**Clarification to and update of Regulation No. 83 regarding the particle number measurement
procedure**

Proposal for a Corrigendum to the 05 series of amendments to Regulation No. 83
(Emissions of M_1 and N_1 vehicles)

Submitted by the expert from the United Kingdom

Figure 13: Particulate sampling probe configuration

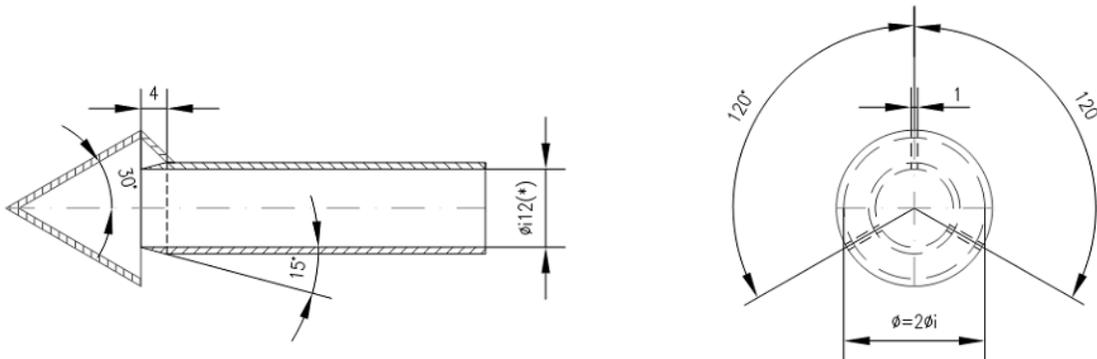
Annex 4a, Appendix 4, Figure 13, replace with:

The proposed replacement to Figure 13 corrects an error in the current figure which appears to show the 12 mm probe diameter as being the external, rather than the internal, diameter.

(*) minimum internal diameter

Wall thickness ~1mm - Material: stainless steel
